Responses to Comments on the Draft EA

On November 18, 2019, the FAA released the Draft Environmental Assessment (EA) for the proposed Las Vegas Metroplex Project for public review and comment. The comment period ran for 64 days and closed on January 21, 2020. The FAA recognizes the importance and value of public input in this process.

Figure 2. Aircraft landing at North Las Vegas Airport or Henderson Executive Airport

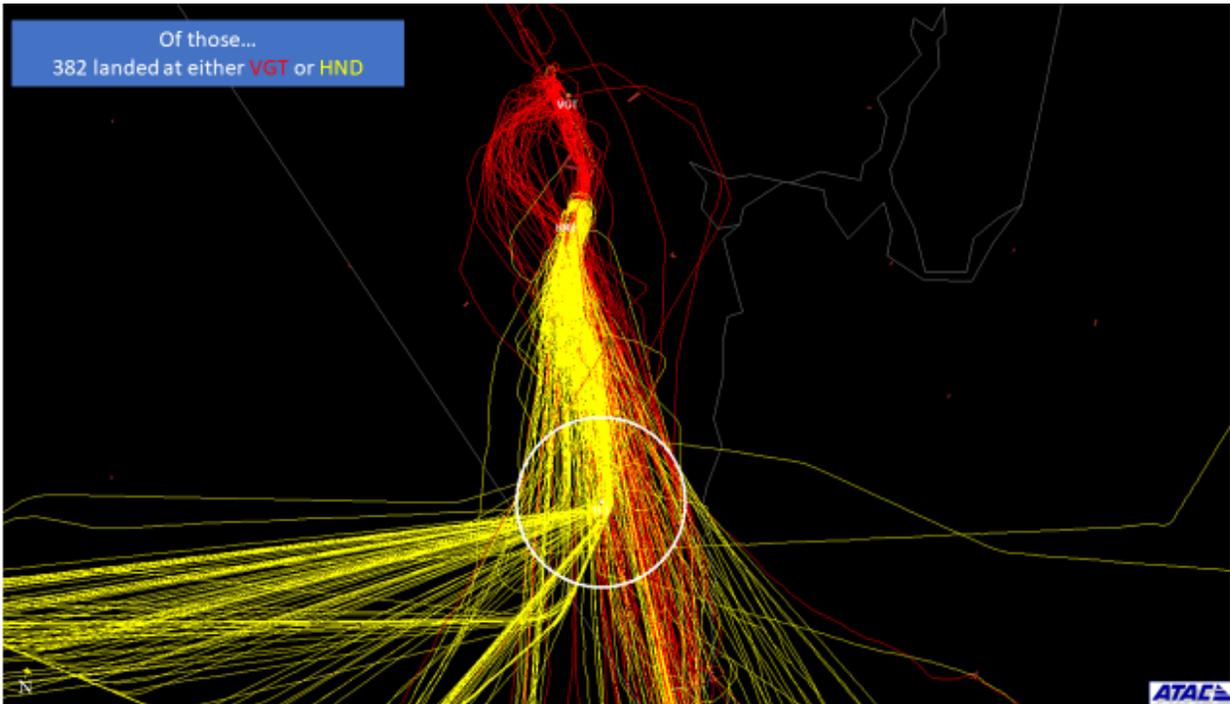
The Federal Aviation Administration (FAA) reviewed historical flight data for the period of October 1, 2019 to December 31, 2019. Using a ten nautical mile diameter circle centered on 1L3, there were a total of 972 flights that entered the defined area at or below 15,000 feet mean sea level, or 11,450 feet above ground level. See **Figure 1**. Of these, 382 landed at either HND or VGT. See **Figure 2**. This number represents only aircraft receiving air traffic control services. There is no way to determine the number of aircraft overflying 1L3 that were not receiving air traffic services.

After review, the FAA determined that the proposed NTNDO arrival procedure could not be moved or eliminated due to safety and efficiency considerations.

Figure 1: GIDGT/RATPK Extended to Blue Diamond Road

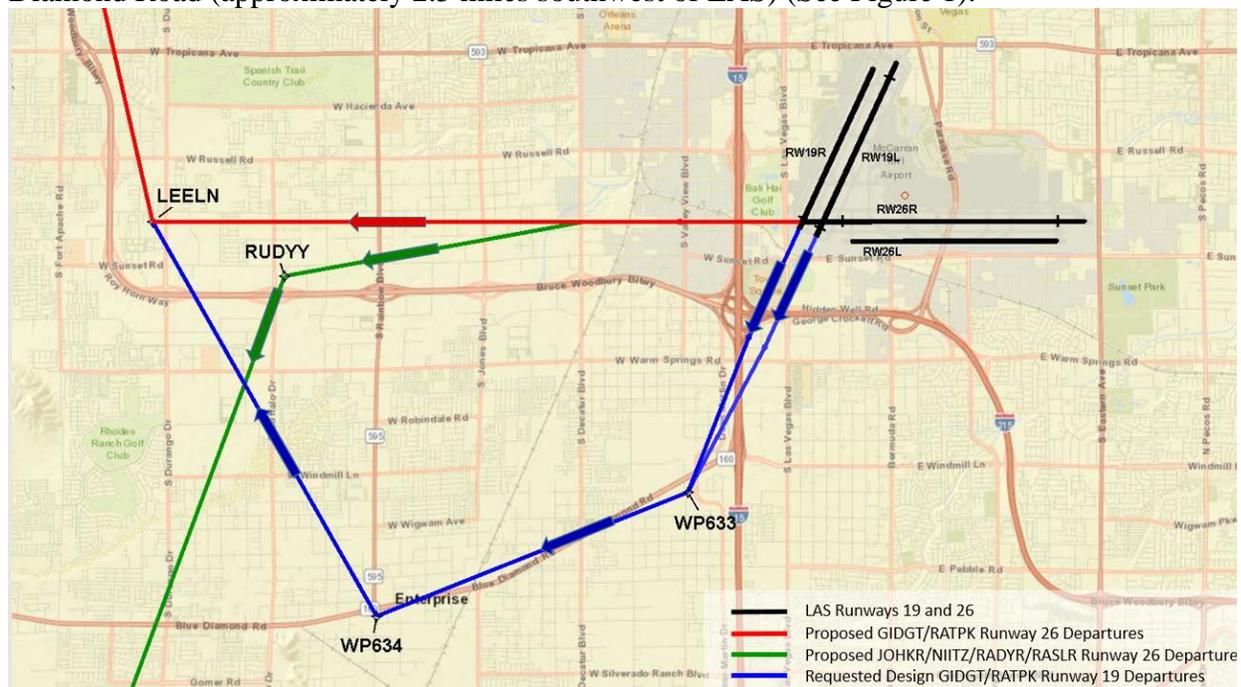
The FAA evaluated a design that delayed making a right turn to LEELN until crossing Blue Diamond Road (approximately 2.5 miles southwest of LAS) (See Figure 1).

The FAA determined that in addition to the criteria failures, the suggested route over Blue Diamond Road would reduce efficiency due to increased delays for departures from separate runways and increase miles flown. Also, extension of the RATPK and GIDGT departure procedures could present a situation where LAS Runway 19 departures would be routed nearly head on toward aircraft on LAS JOHKR, NIITZ, RASLR and RAYDR departure procedures departing LAS Runway 26 (See Figure 1).

Figure 1: GIDGT/RATPK Extended to Blue Diamond Road

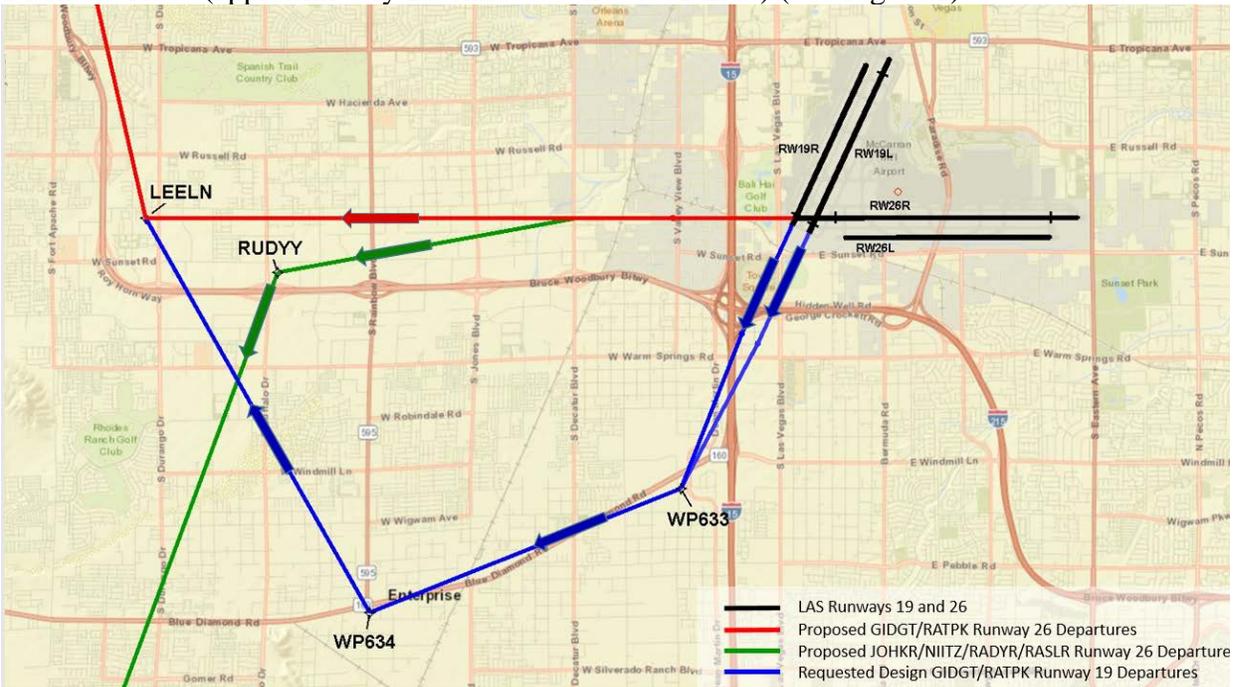
The FAA evaluated a design that delayed making a right turn to LEELN until crossing Blue Diamond Road (approximately 2.5 miles southwest of LAS) (See Figure 1).

head on toward aircraft on LAS JOHKR, NIITZ, RASLR and RAYDR departure procedures departing LAS Runway 26 (See Figure 1).

Figure 1: GIDGT/RATPK Extended to Blue Diamond Road

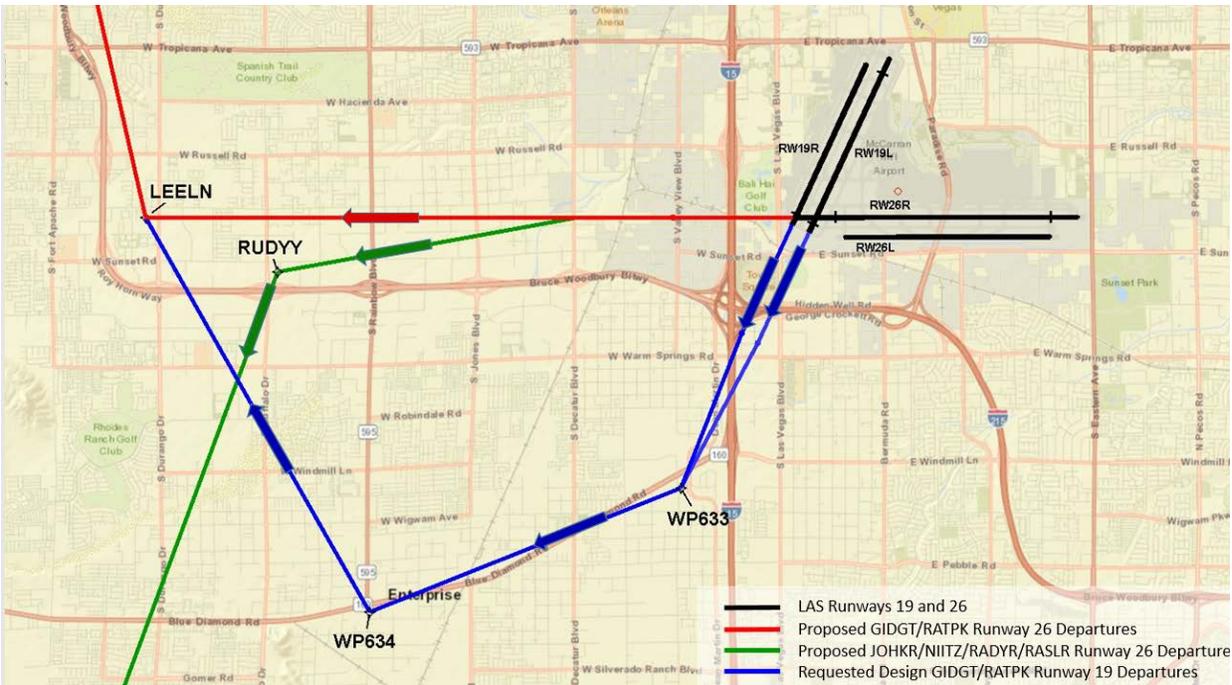
The FAA evaluated a design that delayed making a right turn to LEELN until crossing Blue Diamond Road (approximately 2.5 miles southwest of LAS) (See Figure 1).

The FAA determined that in addition to the criteria failures, the suggested route over Blue Diamond Road would reduce efficiency due to increased delays for departures from separate runways and increase miles flown. Also, extension of the RATPK and GIDGT departure procedures could present a situation where LAS Runway 19 departures would be routed nearly head on toward aircraft on LAS JOHKR, NIITZ, RASLR and RAYDR departure procedures departing LAS Runway 26 (See Figure 1).

Figure 1: GIDGT/RATPK Extended to Blue Diamond Road

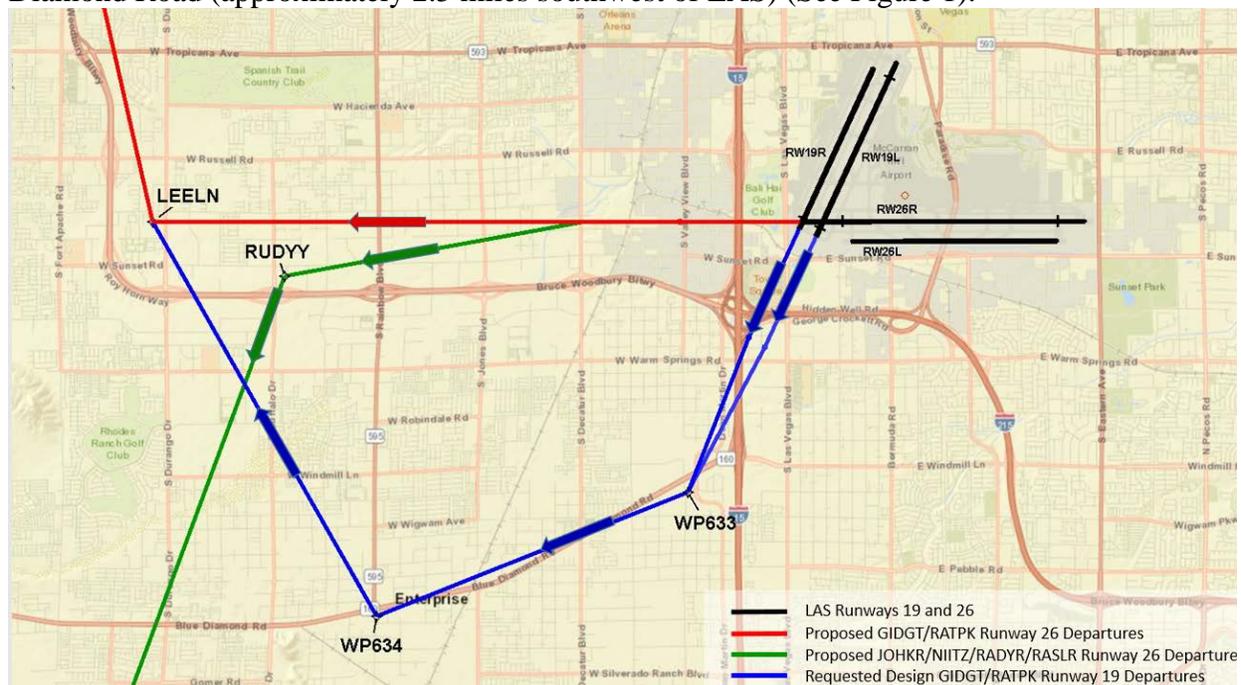
The FAA evaluated a design that delayed making a right turn to LEELN until crossing Blue Diamond Road (approximately 2.5 miles southwest of LAS) (See Figure 1).

The FAA determined that in addition to the criteria failures, the suggested route over Blue Diamond Road would reduce efficiency due to increased delays for departures from separate runways and increase miles flown. Also, extension of the RATPK and GIDGT departure procedures could present a situation where LAS Runway 19 departures would be routed nearly head on toward aircraft on LAS JOHKR, NIITZ, RASLR and RAYDR departure procedures departing LAS Runway 26 (See Figure 1).

Figure 1: GIDGT/RATPK Extended to Blue Diamond Road

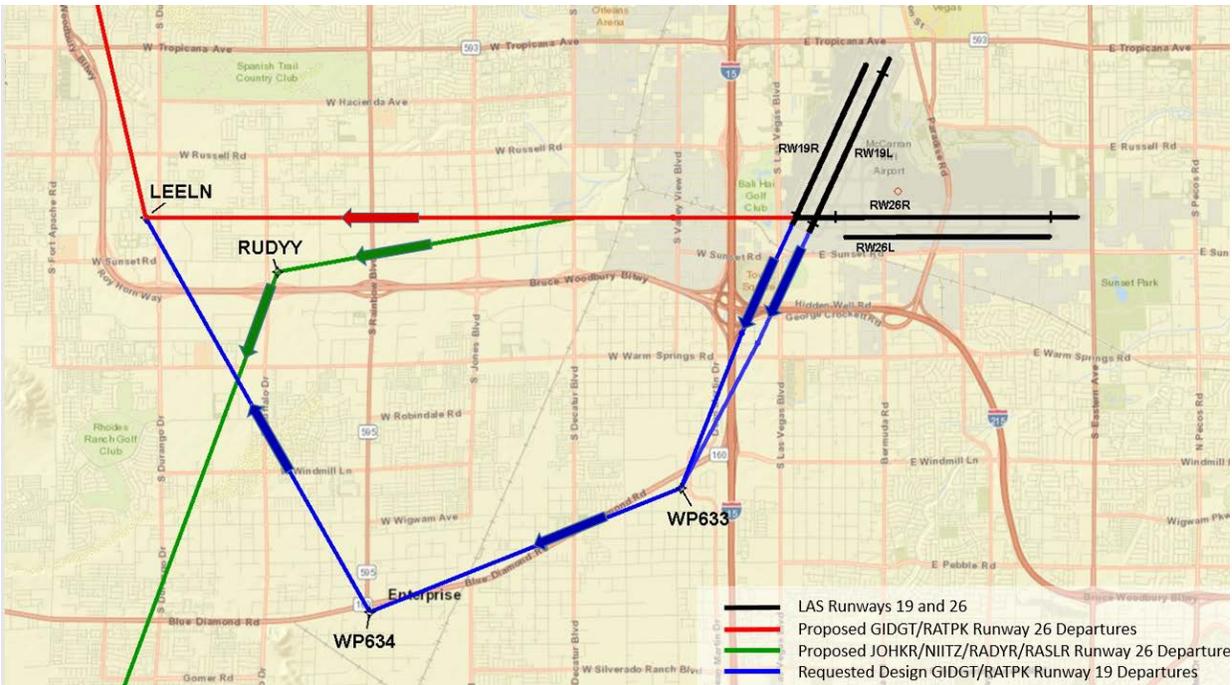
The FAA evaluated a design that delayed making a right turn to LEELN until crossing Blue Diamond Road (approximately 2.5 miles southwest of LAS) (See Figure 1).

The FAA determined that in addition to the criteria failures, the suggested route over Blue Diamond Road would reduce efficiency due to increased delays for departures from separate runways and increase miles flown. Also, extension of the RATPK and GIDGT departure procedures could present a situation where LAS Runway 19 departures would be routed nearly head on toward aircraft on LAS JOHKR, NIITZ, RASLR and RAYDR departure procedures departing LAS Runway 26 (See Figure 1).

Figure 1. Flight Tracks over or near 1L3 at or below 15,000 feet above mean sea level

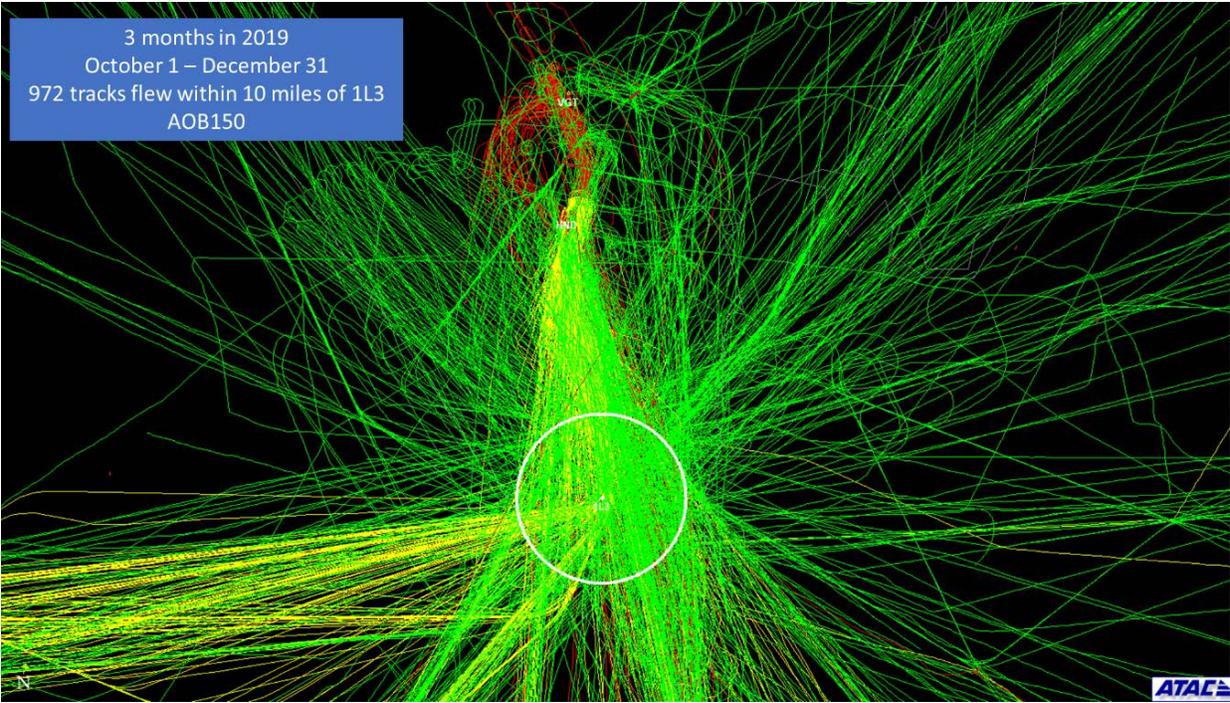
The Federal Aviation Administration (FAA) reviewed historical flight data for the period of October 1, 2019 to December 31, 2019. Using a ten nautical mile diameter circle centered on 1L3, there were a total of 972 flights that entered the defined area at or below 15,000 feet mean sea level, or 11,450 feet above ground level. See **Figure 1**. Of these, 382 landed at either HND or VGT. See **Figure 2**. This number represents only aircraft receiving air traffic control services. There is no way to determine the number of aircraft overflying 1L3 that were not receiving air traffic services.

After review, the FAA determined that the proposed NTNDO arrival procedure could not be moved or eliminated due to safety and efficiency considerations.

Figure 1. Flight Tracks over or near 1L3 at or below 15,000 feet above mean sea level

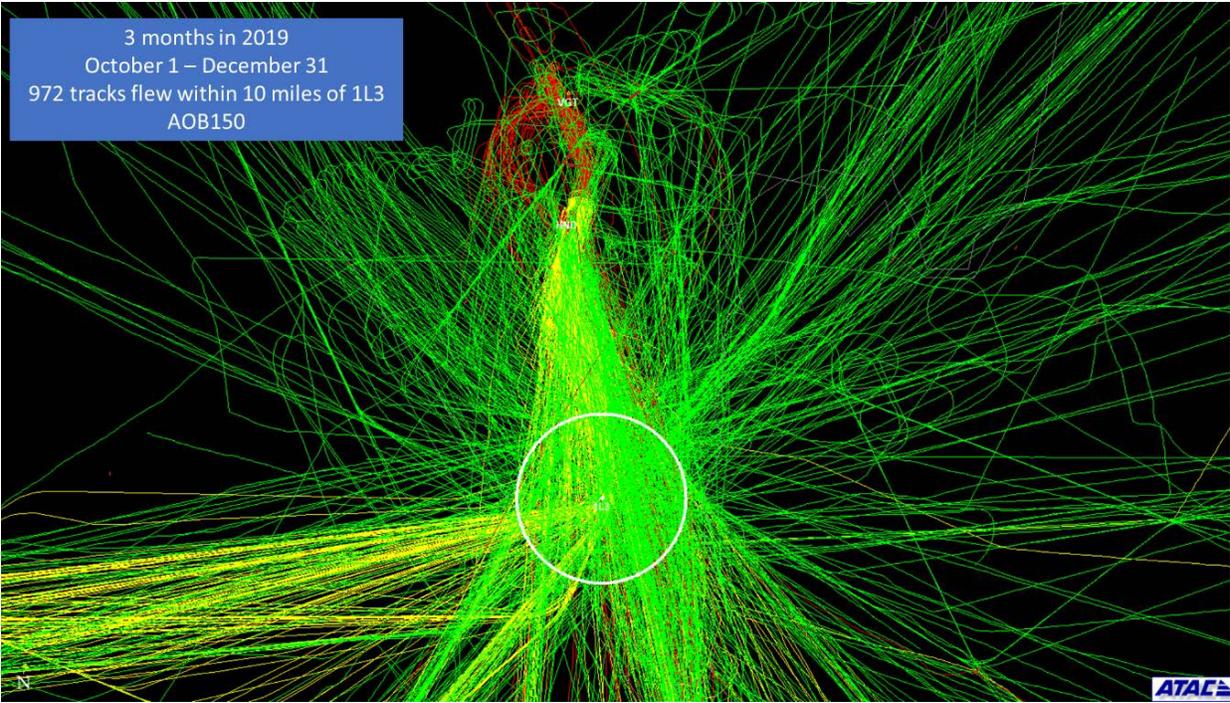
The Federal Aviation Administration (FAA) reviewed historical flight data for the period of October 1, 2019 to December 31, 2019. Using a ten nautical mile diameter circle centered on 1L3, there were a total of 972 flights that entered the defined area at or below 15,000 feet mean sea level, or 11,450 feet above ground level. See **Figure 1**. Of these, 382 landed at either HND or VGT. See **Figure 2**. This number represents only aircraft receiving air traffic control services. There is no way to determine the number of aircraft overflying 1L3 that were not receiving air traffic services.

After review, the FAA determined that the proposed NTNDO arrival procedure could not be moved or eliminated due to safety and efficiency considerations.

Figure 1: GIDGT/RATPK Extended to Blue Diamond Road

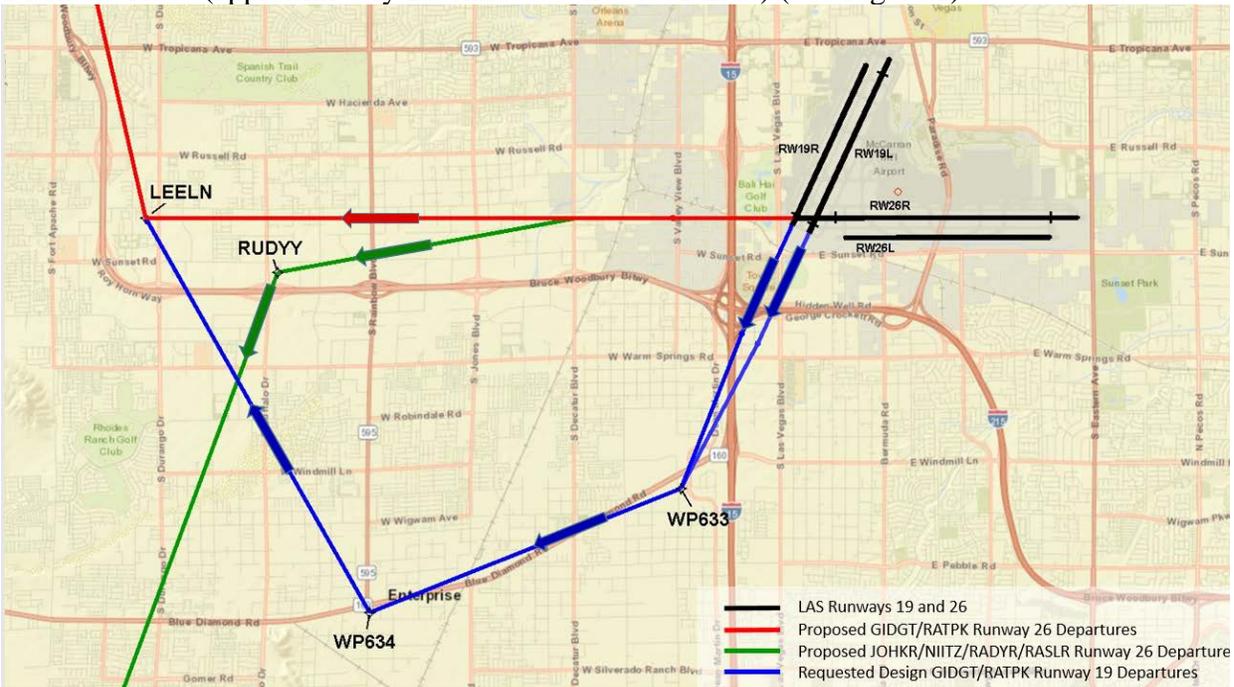
The FAA evaluated a design that delayed making a right turn to LEELN until crossing Blue Diamond Road (approximately 2.5 miles southwest of LAS) (See Figure 1).

head on toward aircraft on LAS JOHKR, NIITZ, RASLR and RAYDR departure procedures departing LAS Runway 26 (See Figure 1).

Figure 1: GIDGT/RATPK Extended to Blue Diamond Road

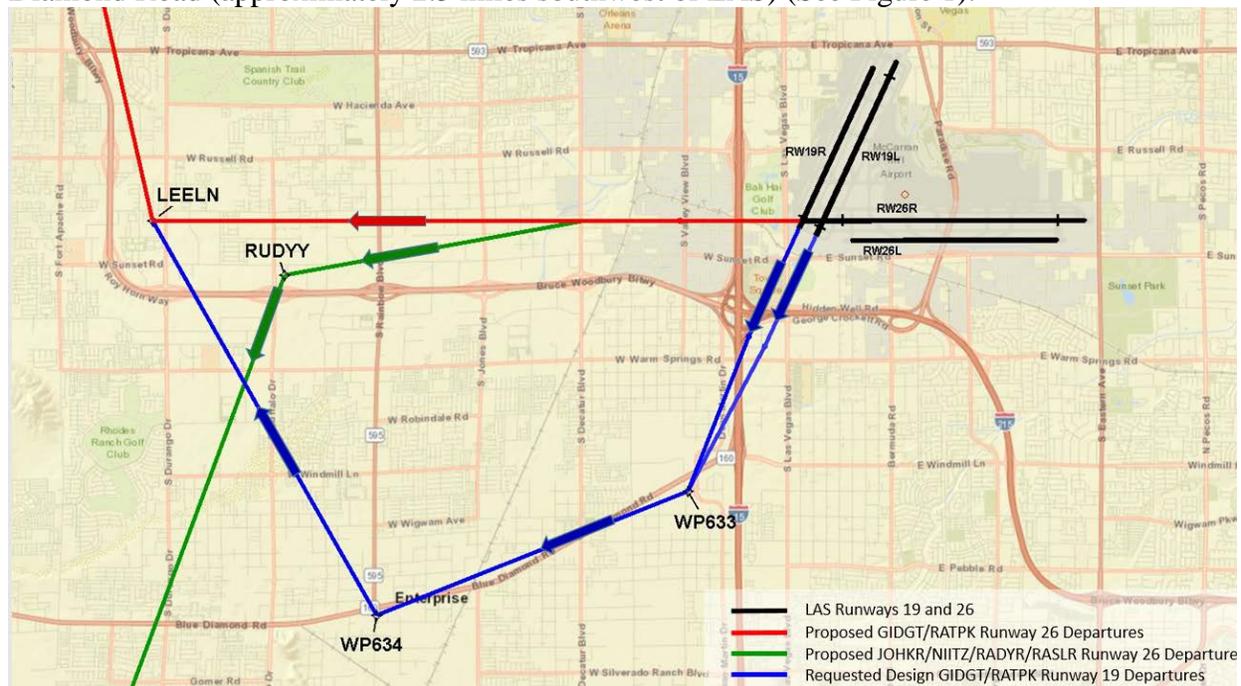
The FAA evaluated a design that delayed making a right turn to LEELN until crossing Blue Diamond Road (approximately 2.5 miles southwest of LAS) (See Figure 1).

The FAA determined that in addition to the criteria failures, the suggested route over Blue Diamond Road would reduce efficiency due to increased delays for departures from separate runways and increase miles flown. Also, extension of the RATPK and GIDGT departure procedures could present a situation where LAS Runway 19 departures would be routed nearly head on toward aircraft on LAS JOHKR, NIITZ, RASLR and RAYDR departure procedures departing LAS Runway 26 (See Figure 1).

Figure 1: GIDGT/RATPK Extended to Blue Diamond Road

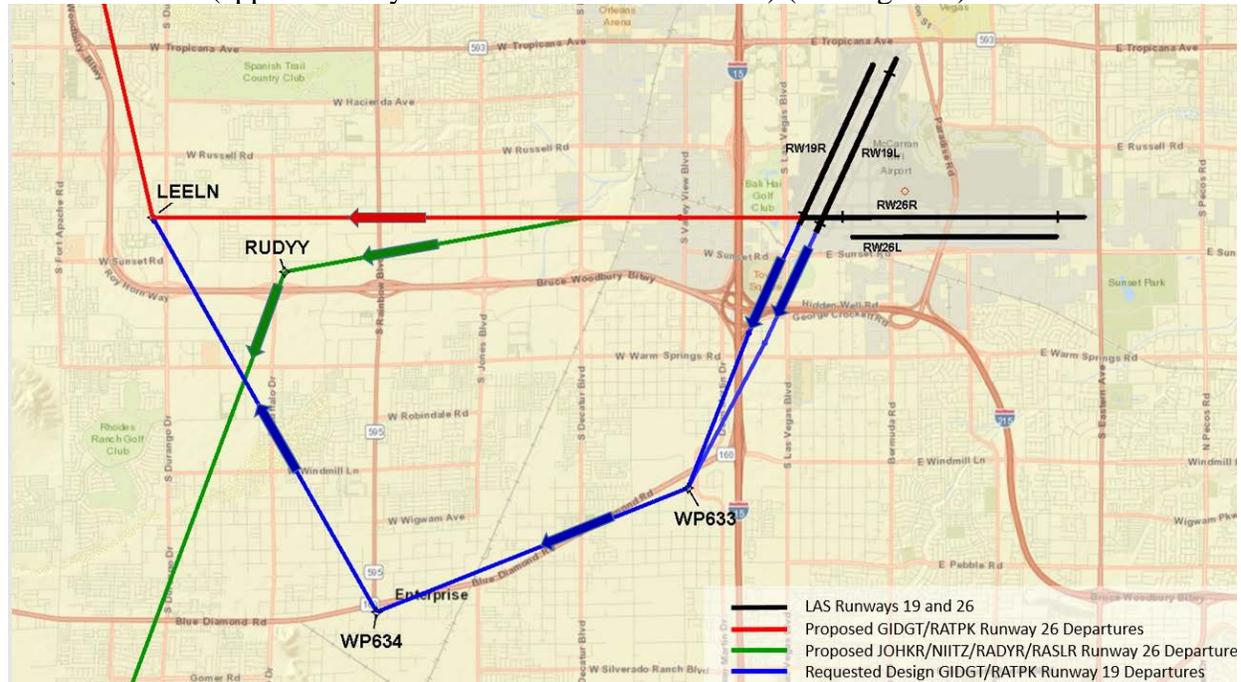
The FAA evaluated a design that delayed making a right turn to LEELN until crossing Blue Diamond Road (approximately 2.5 miles southwest of LAS) (See Figure 1).

The FAA determined that in addition to the criteria failures, the suggested route over Blue Diamond Road would reduce efficiency due to increased delays for departures from separate runways and increase miles flown. Also, extension of the RATPK and GIDGT departure procedures could present a situation where LAS Runway 19 departures would be routed nearly head on toward aircraft on LAS JOHKR, NIITZ, RASLR and RAYDR departure procedures departing LAS Runway 26 (See Figure 1).
